# Memorandum

Re: Comments on the Draft Foundation Investigation and Design Report  
Sloan Culvert Replacement, Hwy 101 approximately 8.5km of Hwy 7072  
Township of Ivanhoe – Site 46-542  
GWP No.: 5464-08-01

We have evaluated the Draft Foundation Investigation and Design Report for the above noted project produced by DST Consulting Engineers Inc dated October 20 2010. The report was received by our office on October 21, 2010 under Genivar Transmittal email.

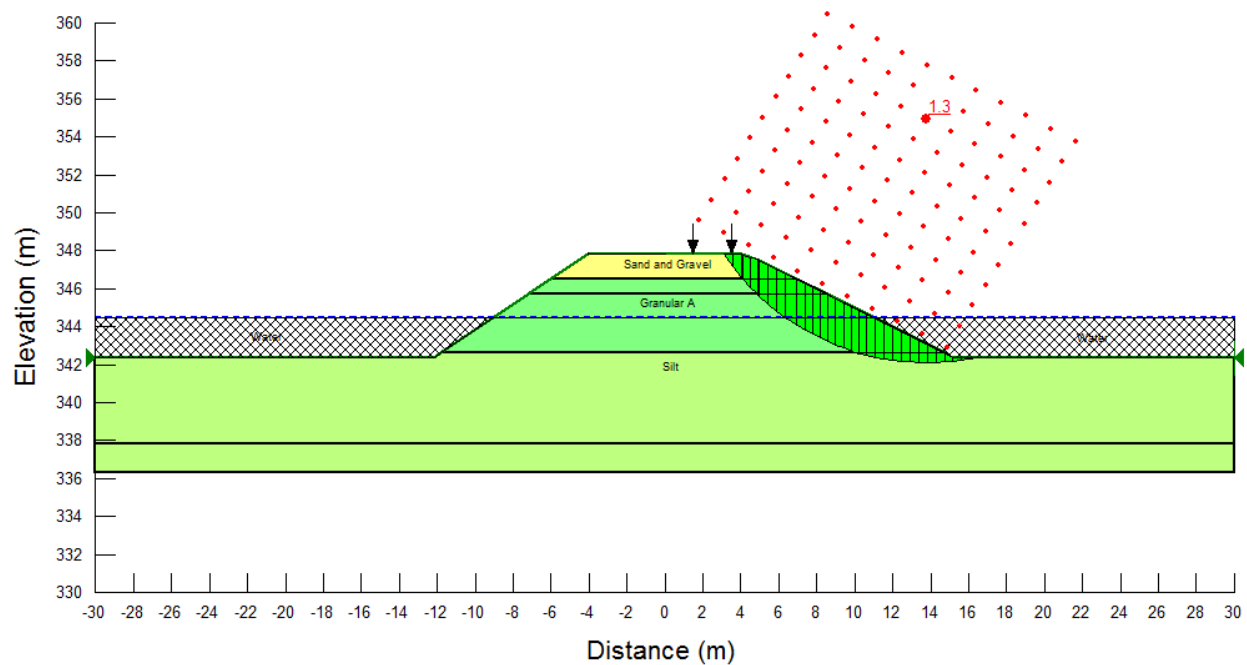
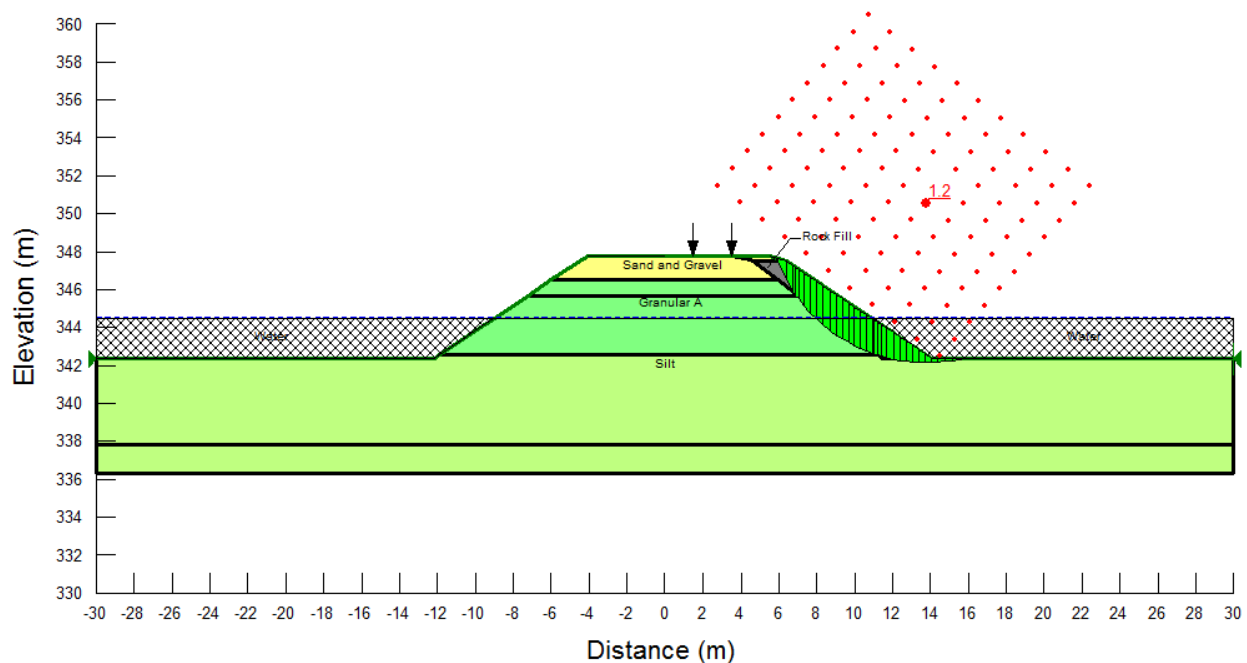
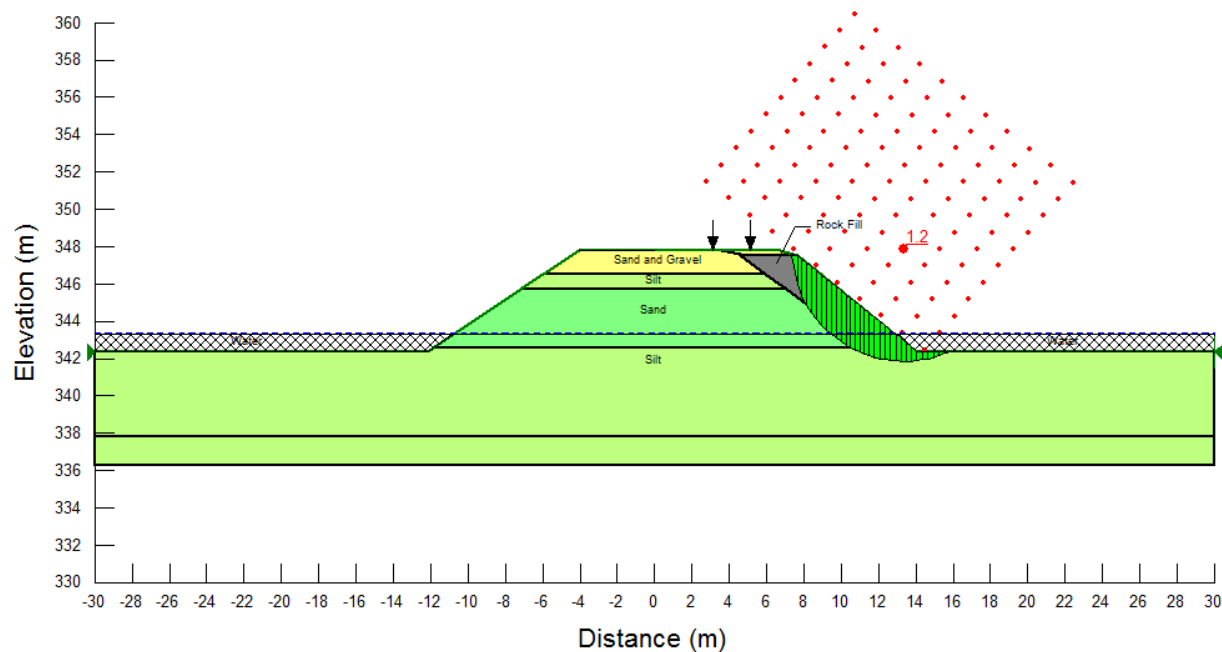
9. Section 5.1.4 Embankment Design (page 11) – Slope stability sections analyzed should be presented, parameters and approach should be described and results concluded.

Embankment design for new staged construction with widening has been added to the

evaluated conditions. A table summarizing the conclusions has also been presented. Parameters used are shown in Table 5.3.

DRAWING 2

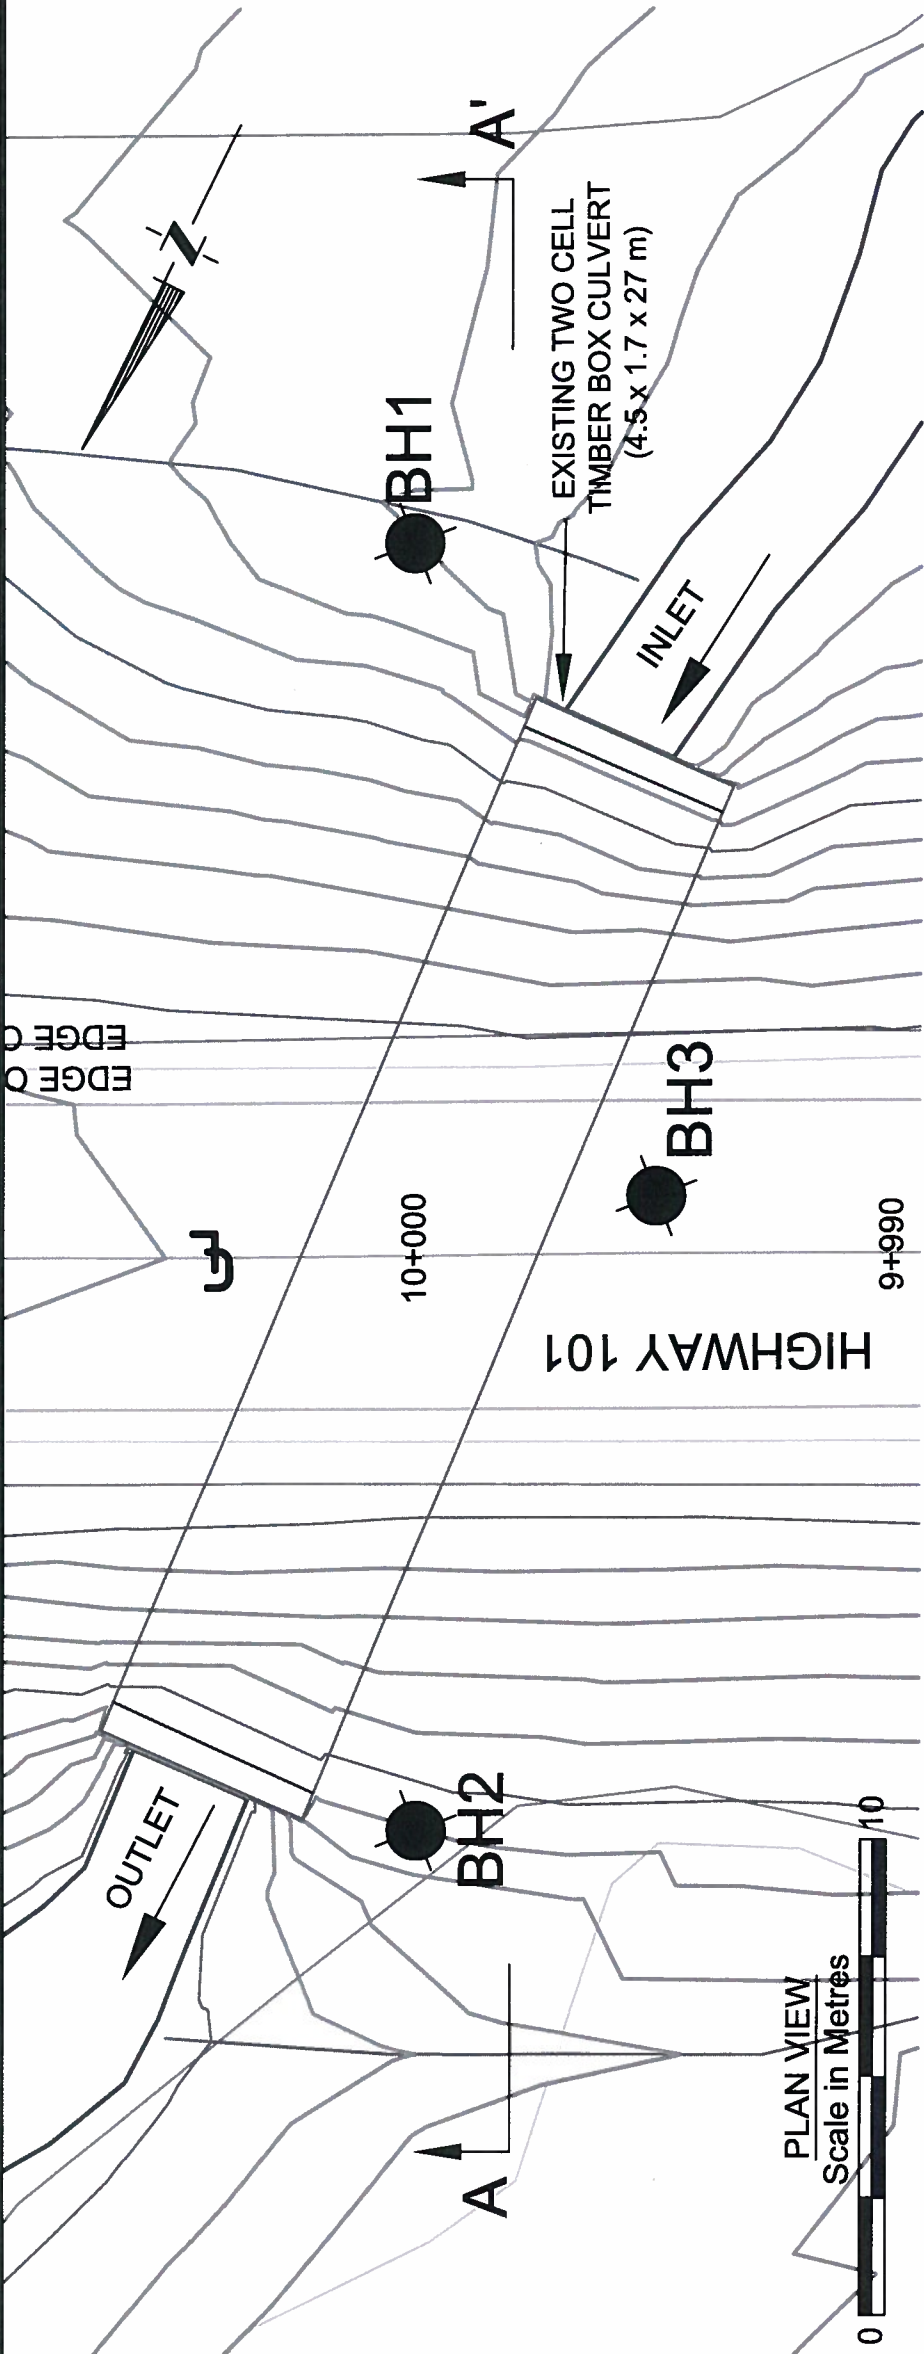
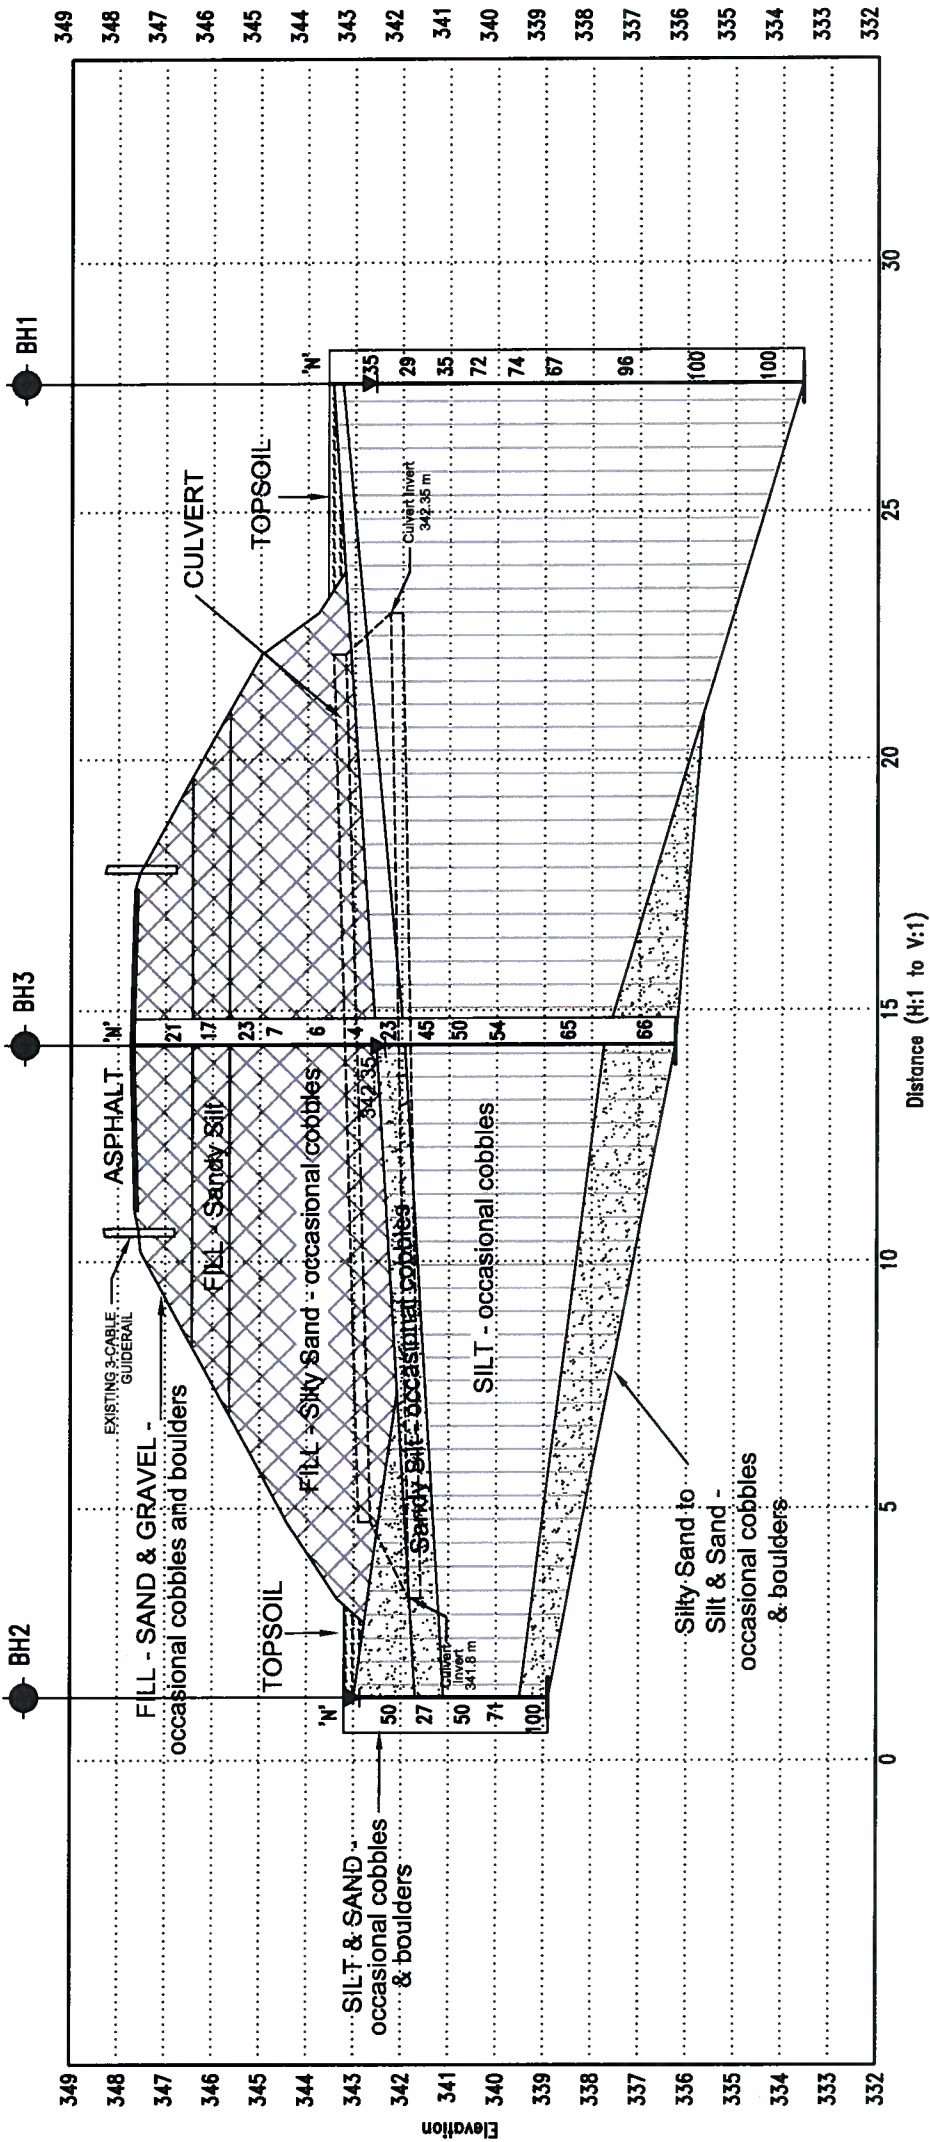
Since cobbles and boulders were identified in the boreholes, drawings 2 to 4 should noted the presence of them on the subsurface profiles.

Corrections have been made. Please refer Drawings 2 to 4.

CULVERT REPLACEMENT  
AT SLOAN CREEK  
Highway 101 - Foleyet Twp.  
STAGE 1

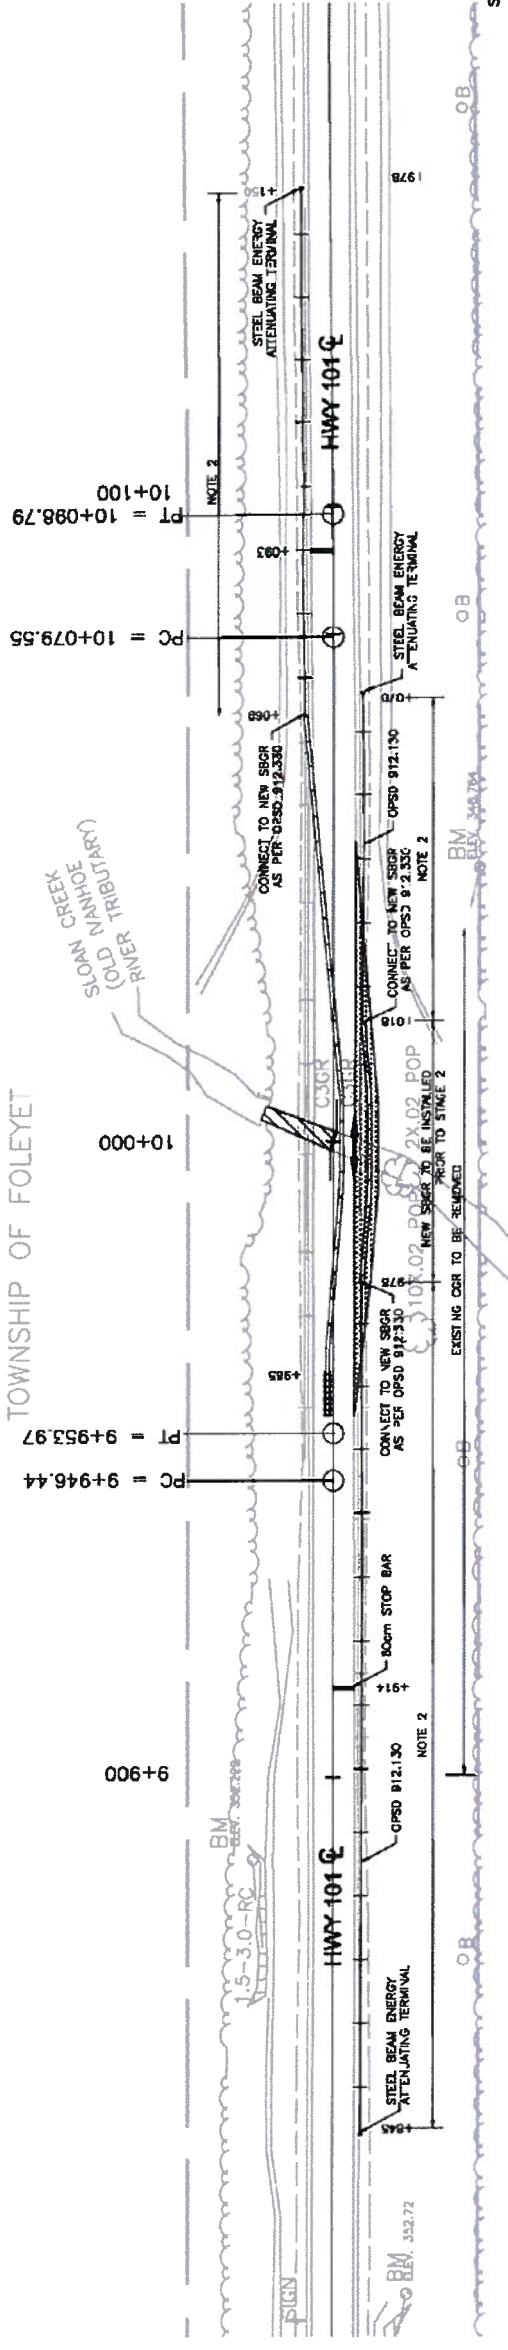
7. General - Cross sections and plan view of staged construction should be presented and described along the report. All stages shall be analyzed and verified regarding stability and construction issues. A detailed explanation including elevations is required.

Staging drawings added as Drawings 5 and 6. The slope stability conditions were evaluated for all stages and are presented in Section 5.1.4 Embankment Design.
